Appl. No.: 10/707,927
Amdt. Dated: 1/8/2006
Reply to Office action of: 10/28/2005

AMENDMENTS TO THE DRAWINGS:

REMARKS/ARGUMENTS

Appl. No. 10/707,927
Amdt. Dated 01/08/2006
Reply to Office action of 10/28/2005
Annotated Sheet Showing Changes

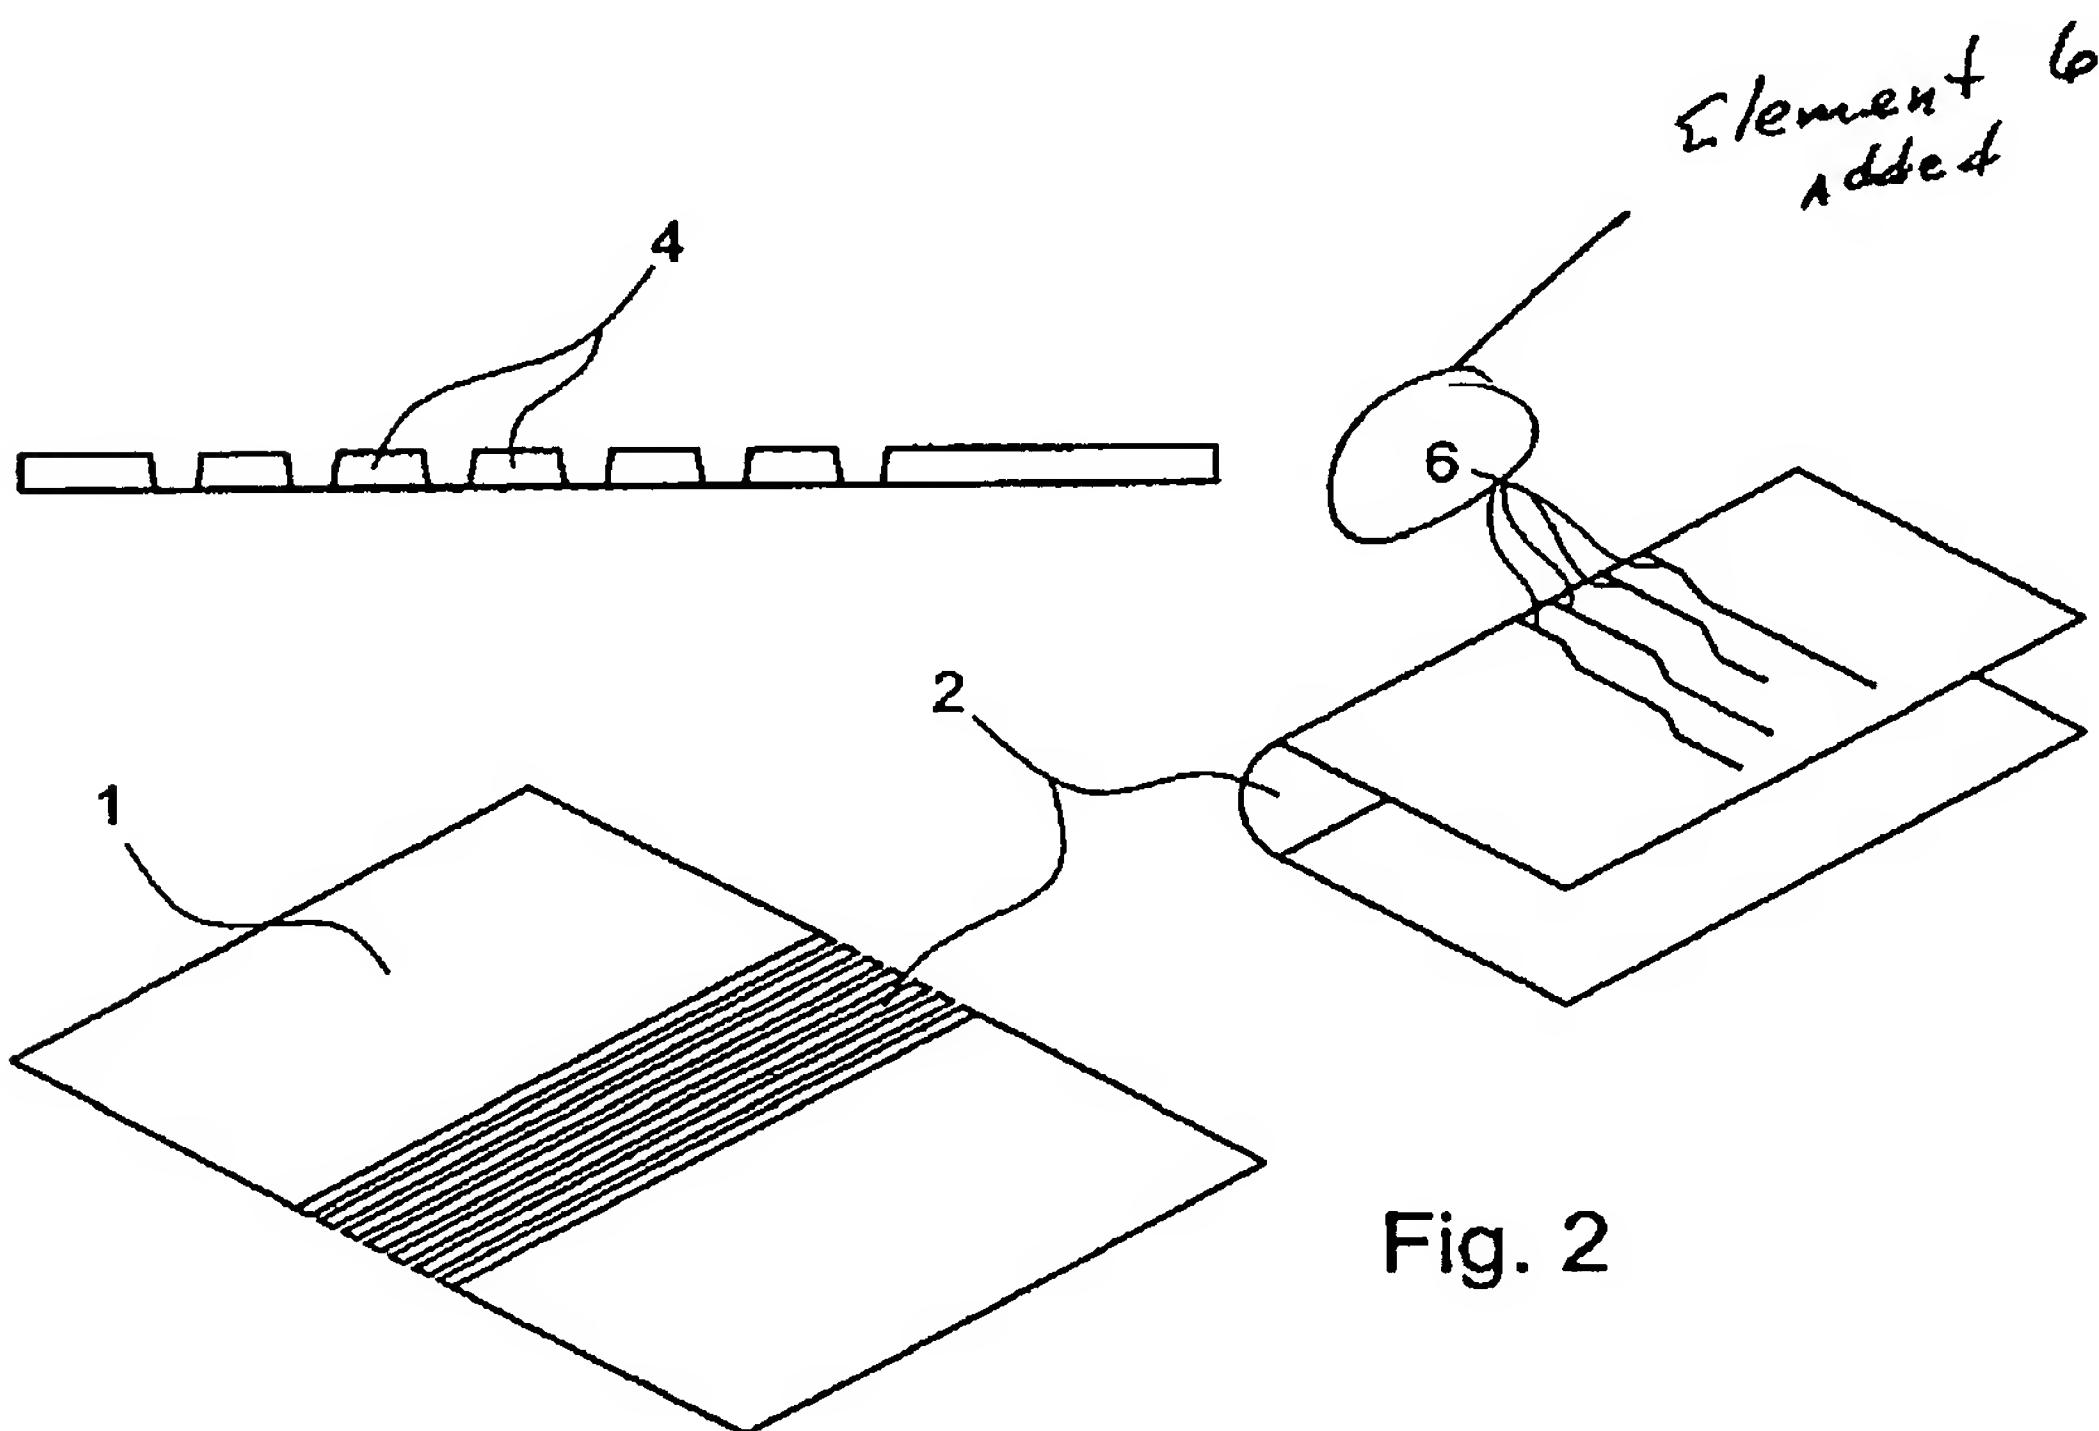
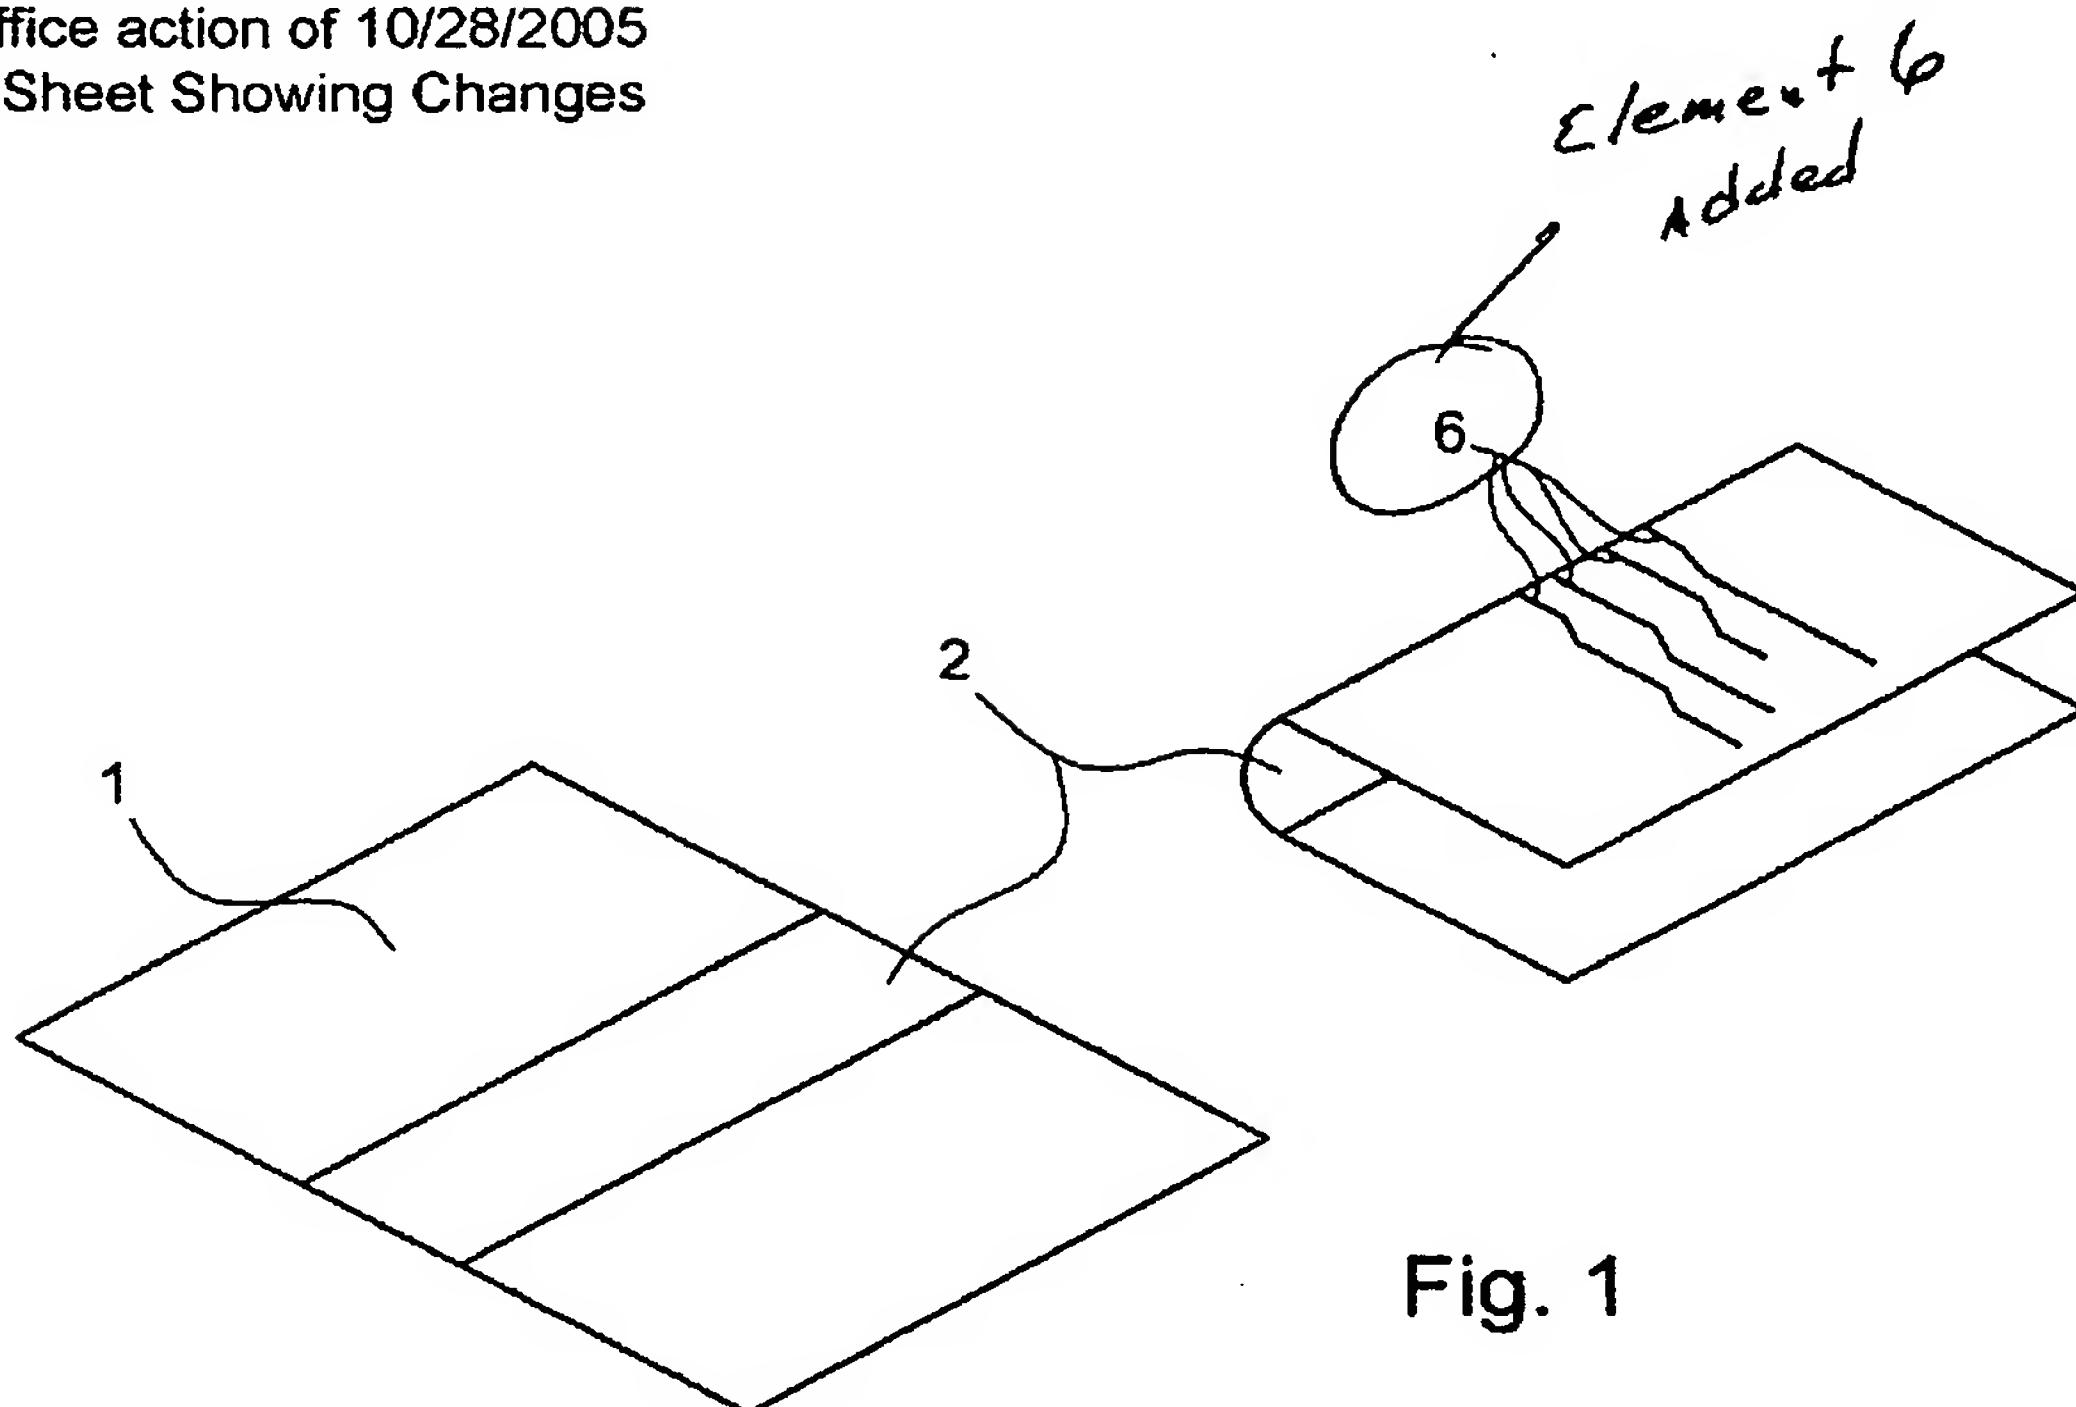
The attached sheet(s) of drawings includes changes to Figure 1 and 2 and the addition of new Figure 4. In Figures 1 and 2 the previously omitted element 6 has been added. New Figure 4 illustrates the circuit board substrate and conductive tracks disclosed in the specification but previously omitted from the drawings.

In amended Figures 1 and 2, the previously omitted element numeral 6 has been added. In new Figure 4 the substrate and conductive tracks of the printed circuit board have been clearly illustrated as required by the Examiner.
